**RE: NUREG-2176 – Letter from Mayor Regalado, City of Miami (NRC-2009-0337)**

**RE: NUREG-2176 – City of Miami’s Comments on Draft Environmental Impact Statement for Combined Licenses (COLs) for Turkey Point Nuclear Plant Units 6 & 7 (NRC-2009-0337)**

The City of Miami (“the City” or “Miami”) appreciates the opportunity to submit these comments on the draft Environmental Impact Statement (“DEIS”) for the Turkey Point Nuclear Plant Units 6 & 7 application, published in February 2015.

**Figure 2. Hydraulic Conductivity of the FPL Biscayne aquifer model.**

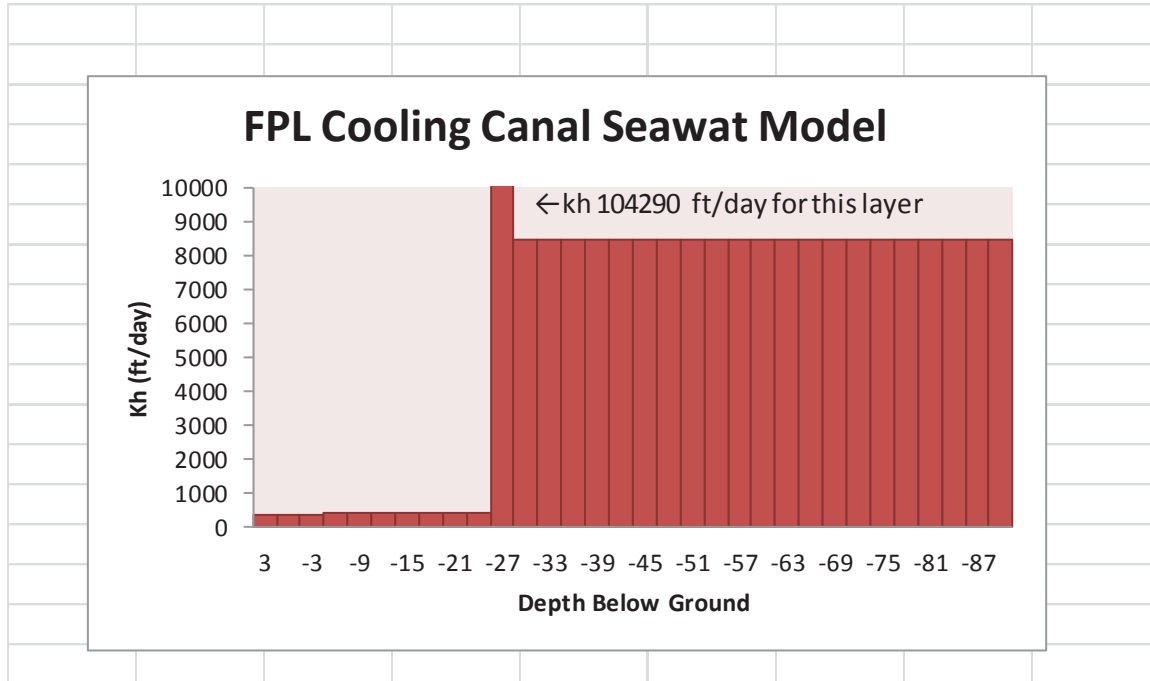
The use of a constant thickness and constant hydraulic conductivity for each layer of a model that stretches 136,000 feet across the Biscayne aquifer is a highly simplified representation of the groundwater system. FPL states that “No attempt was made to approximate the thinning of the aquifer to the west as it was believed that thickness changes would have an insignificant effect on model transmissivity given variability in hydraulic conductivity”. This simplifying assumption of constant aquifer thickness over the model domain is incorrect and may influence the advective flow component of the model and the associated movement of saline water within the aquifer. The assumption that the hydraulic conductivity does not change across the model and that the highly transmissive zone of the Key Largo Limestone is laterally contiguous at -27 feet NGVD is also questionable. Modification of the model to more accurately reflect the area hydrogeology would require the model to be recalibrated.

**Figure 3. FPL Canal Stages for the Operations Model submitted to SFWMD.**

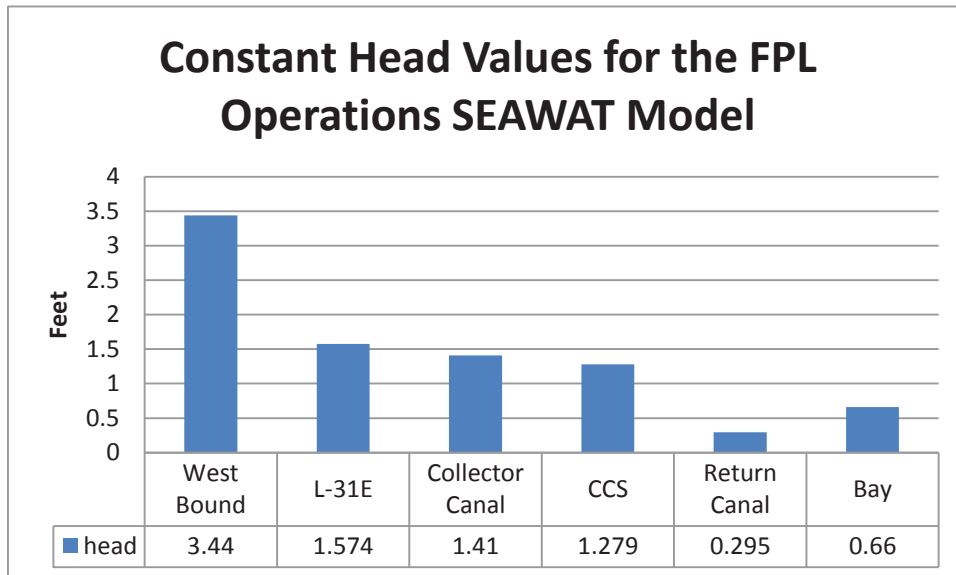
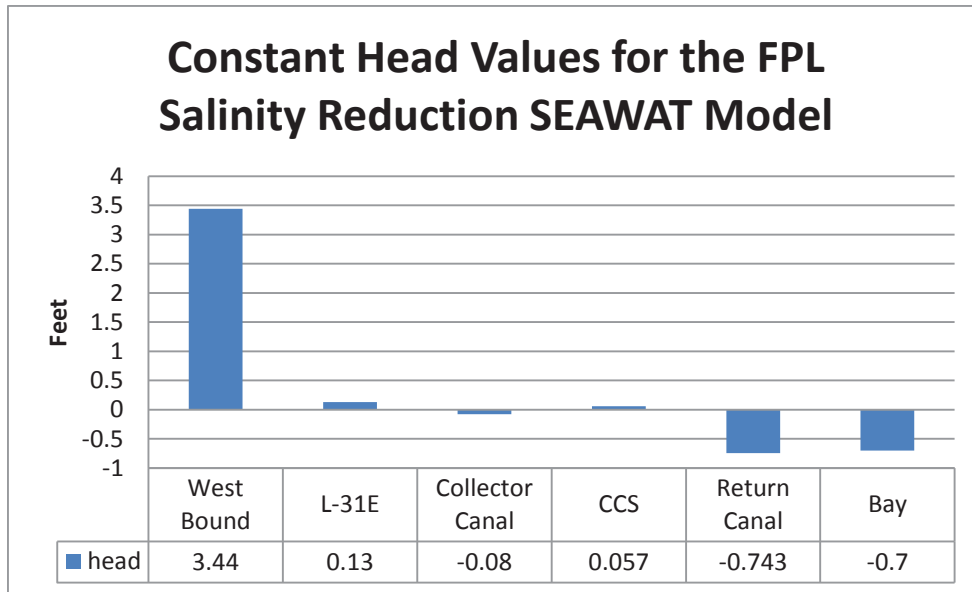
called the salinity reduction simulation, assumes the 14 mgd inflow of brackish water into the CCS and simulates a period of 30 years beginning in 2015. In the historical simulation, FPL assumed all canals and ocean levels were referenced to NGVD. However, for the salinity reduction simulation, they assumed that the canals and ocean on the east use a NAVD datum while the west remains at a NGVD datum. This creates a series of problems because the difference between NAVD and NGVD is 1.53 feet, with NGVD being the higher datum. Basically, by keeping the western boundary at NGVD levels for the salinity reduction run and changing the eastern canals and ocean to reflect NAVD levels, an additional 1.5 foot west-to-east head gradient is artificially introduced into the simulation. Furthermore, the salinity reduction run uses the heads and concentrations from the historical operations run which means the heads are starting out 1.5 feet higher than they should be.

The topography of southern Miami-Dade County is only several feet above sea level in most of the area except along the Atlantic Coastal ridge. Due to the low topographic and hydrologic gradients of the area, deviations on the order of approximately 1.5 feet could significantly alter local groundwater flow and salinity migration rates and directions. **Figures 3 and 4** show the heads at various points that FPL used in their simulations. The mixing of NAVD and NGVD vertical datums is apparent. Correction of the FPL data to a single datum was needed to assess the effects of FPL's proposed CCS salinity reduction proposal and for the basis of comparison to the historical run and against the sensitivity model runs proposed by District staff.

Figure 7. Simulated and observed water quality concentrations for well G-21 Deep.

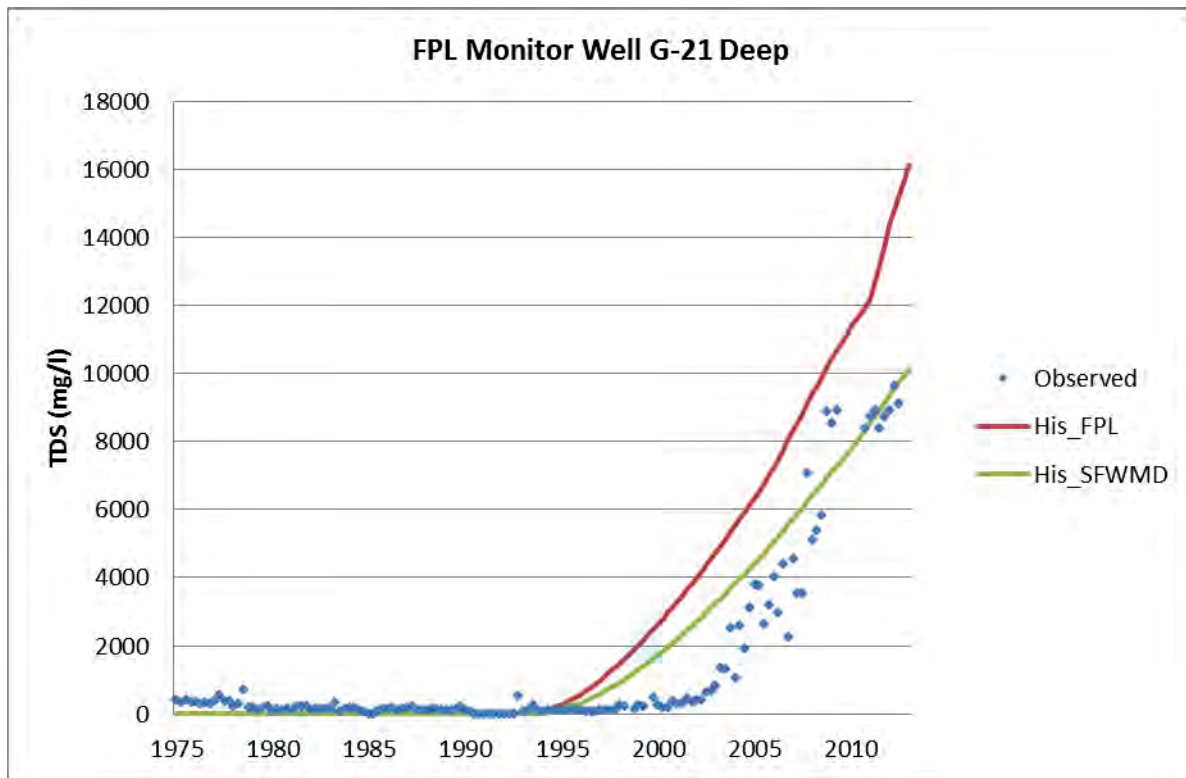
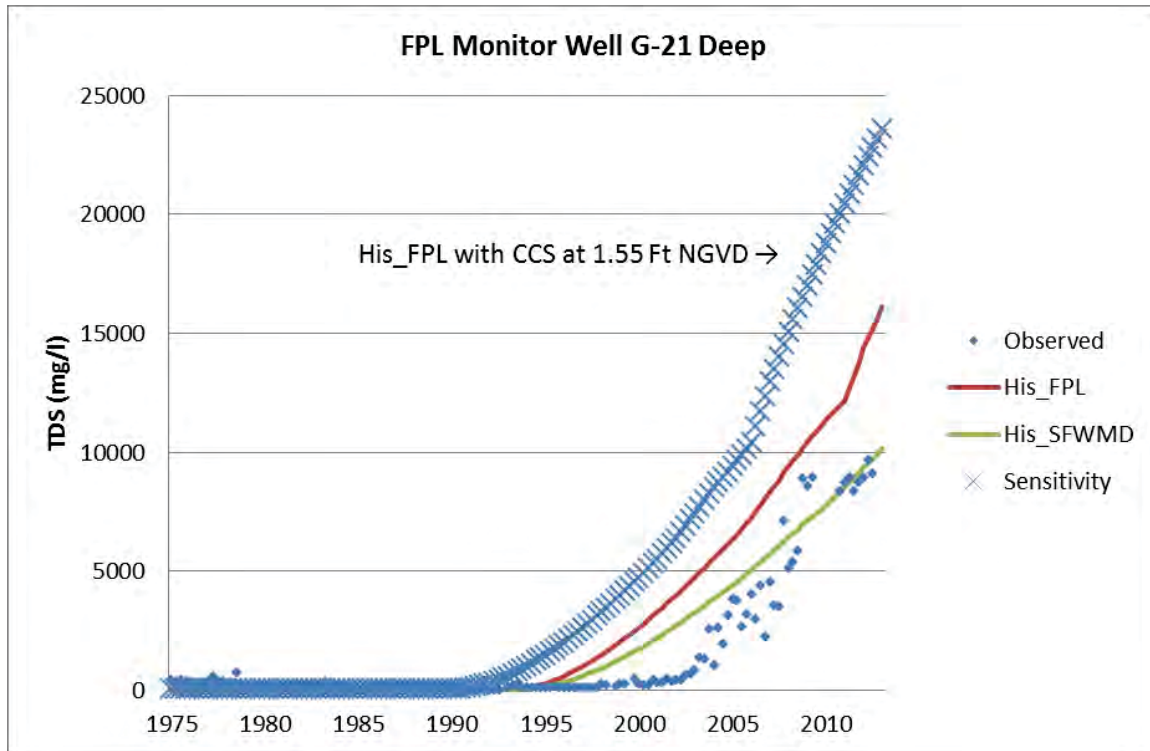
While the FPL report does compare historic salinity monitoring data to the model-calculated response, there is no information to describe whether the model reasonably represents groundwater stage and gradients. Comparison of groundwater stage data using monitoring data from wells located along the model transect to model-calculated stage data would provide valuable insights into the reasonableness of the models result in representing area hydrology. District staff included this analysis and water levels at well G-21 are shown in **Figure 9**. The observed and simulated water levels are significantly different, with both simulations having water levels approximately 1.0 feet higher than the observed values. This demonstrates the limitations of both models because they do not reflect changes in local hydrology included drainage canals, groundwater withdrawals, rainfall and other factors.

**Figure 9. Water levels at well G-21.**

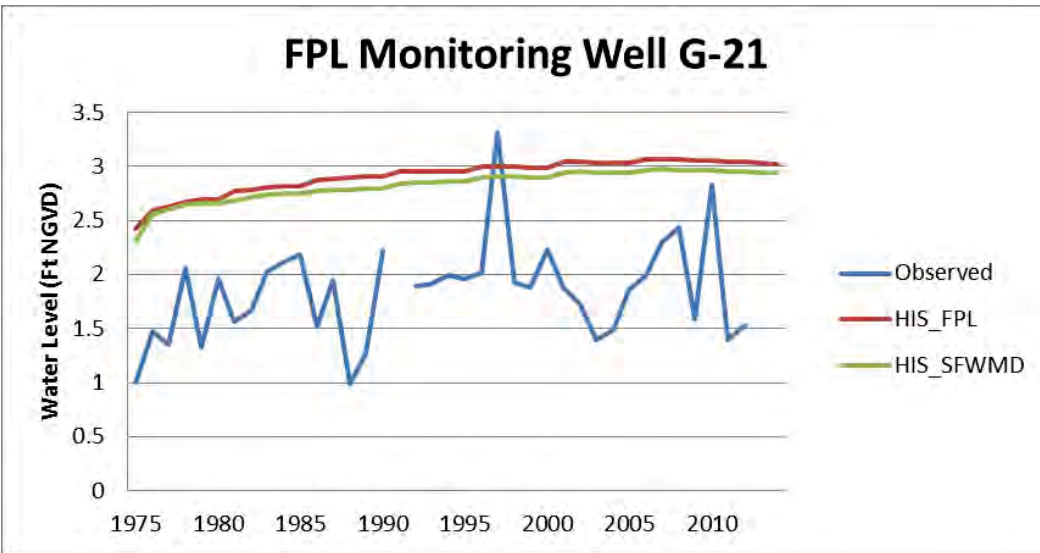
To further illustrate this issue with the model's inability to accurately simulate water levels in the western 1/3 of the model, water levels obtained from the SFWMD South Dade Model' which is a subset of the Lower East Coast Subregional (LECSR) Model (Giddings et. al., 2006), were plotted along the model transect and compared against the results from both the **HIS\_FPL** and **HIS\_SFWMD** simulations. The LECSR model is a highly calibrated model and includes all hydrologic aspects of the system. It is simulated on a daily basis and the results presented here are the average water levels from 1985 through 2000 for the calibration period. **Figure 10** provides the comparison between models.

**Figure 10. Water levels along the model transect.**

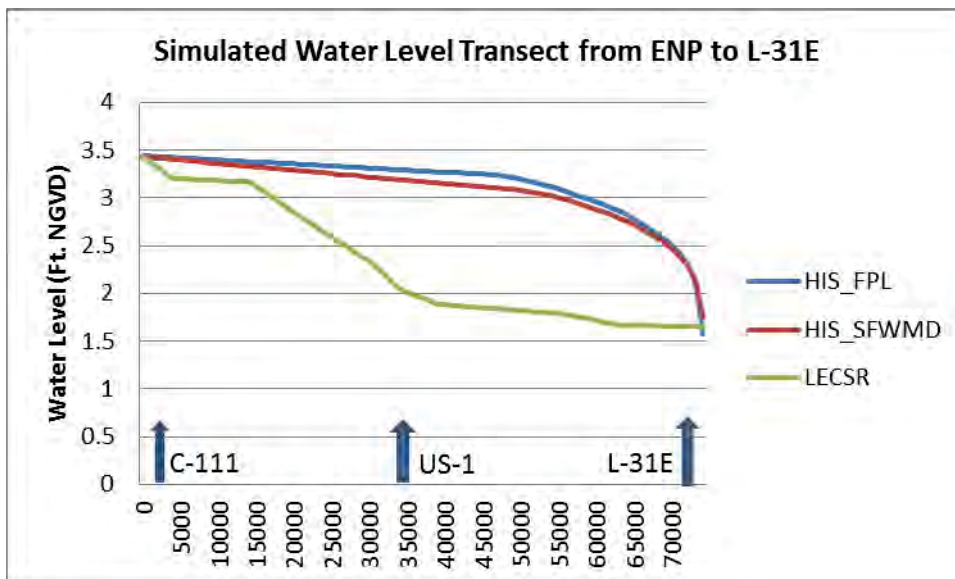
To correct the model to more accurately simulate observed water levels would require wholesale changes to the model parameters and incorporation of packages which simulate actual conditions (i.e.,

Figure 14. Location of the 10,000 mg/l TDS line at the base of the Biscayne aquifer for the FPL simulations.

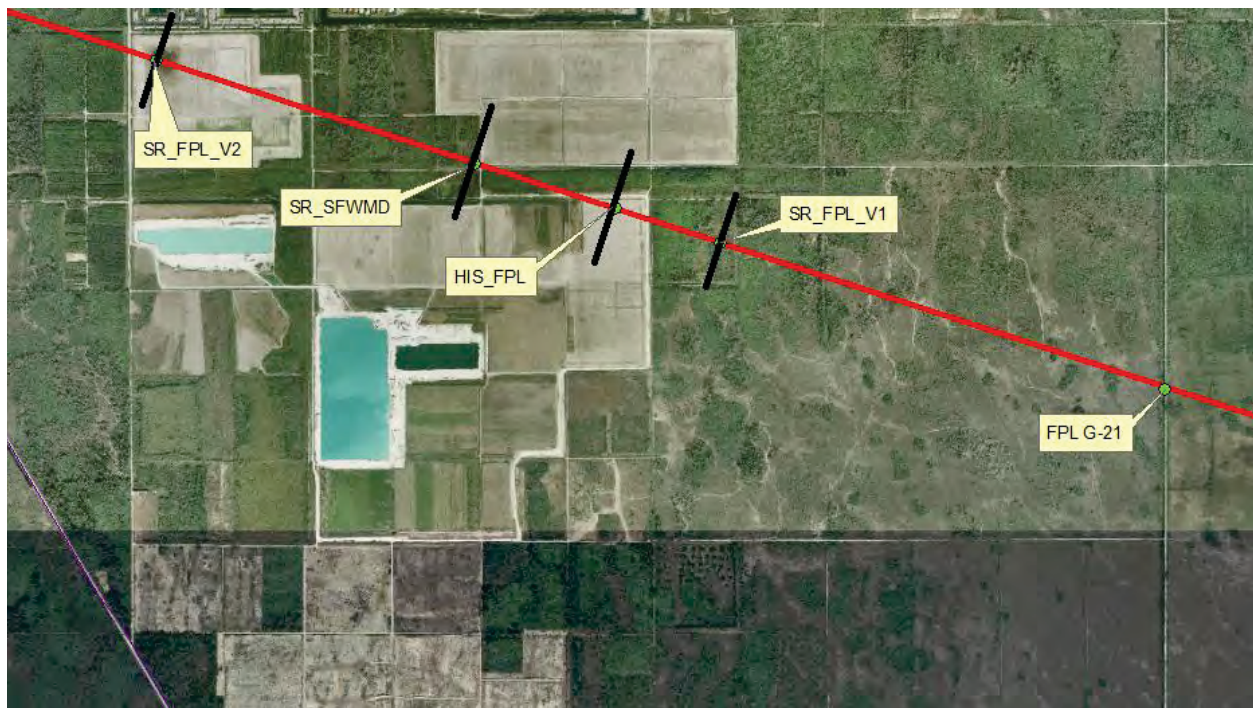
Figure 14 provides the estimated location of the 10,000 mg/l TDS interface at the base of the Biscayne aquifer for the three FPL simulations. In the documentation provided by FPL, it was concluded that the salt water interface would move eastward as a result of the proposed addition of 14 mgd of

fresh/brackish water to the CCS. This is shown by comparing the position of the **HIS\_FPL** and **SR\_FPL\_V1** lines. The position of the **SR\_FPL\_V1** has the incorrect head for the western boundary which gives an inaccurate conclusion. Correcting the head on the western boundary actually results in a westward movement of the interface even with the salinity reduction proposal as shown by the position of the interface at point **SR\_FPL\_V2**. Also note that the position of the interface as predicted by the **SR\_SFWMD** run is eastward of the **SR\_FPL\_V2** run.

**Figure 17. The position of the saline interface (10,000 mg/l TDS) at the base of the Biscayne Aquifer for the future SFWMD simulations.**

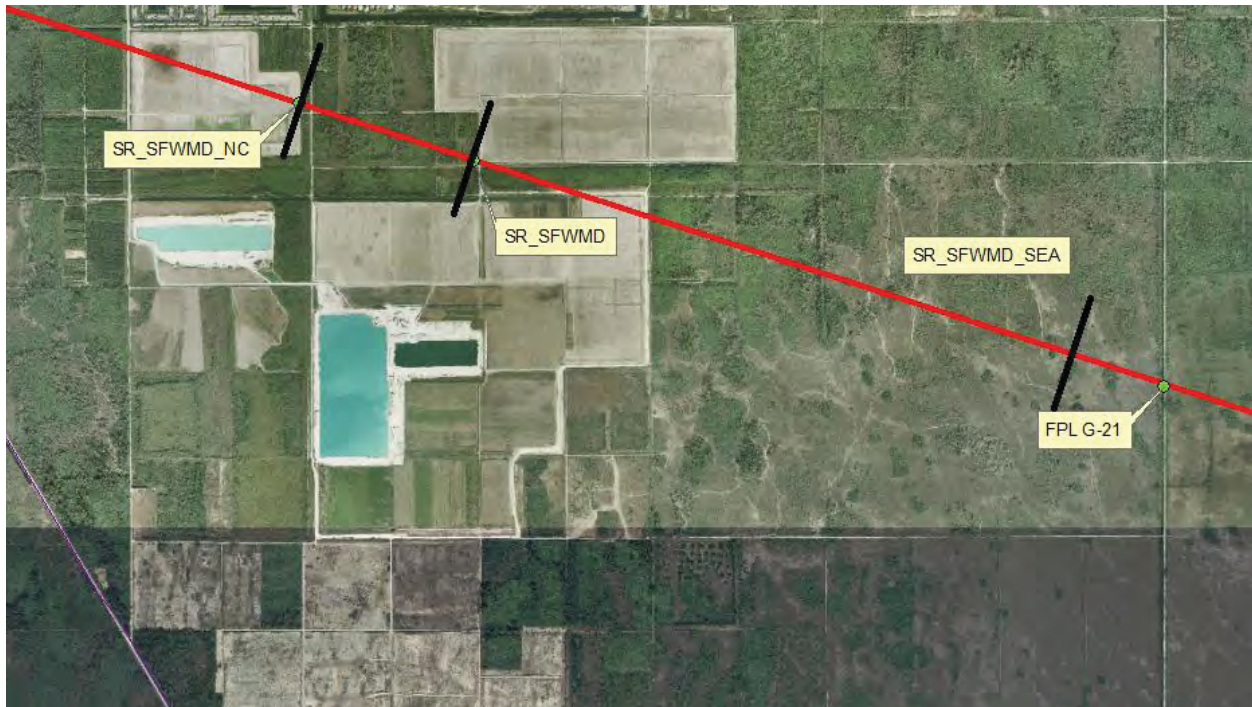
**Figure 17** provides the location of the interface at the base of the Biscayne aquifer for these future simulations. When the 14 md of Floridan aquifer water is added to the CCS, the position of the saline interface (**SR\_SFWMD**) is seaward of the predicted position of the interface if it was not added (**SR\_SFWMD\_NC**). This suggests that the addition of the 14 mgd of Floridan aquifer water would have a net benefit to the Biscayne aquifer if implemented compared to existing conditions and operations. However, the proposal does not fully mitigate the last 40 years of the CCS operating at sea level to
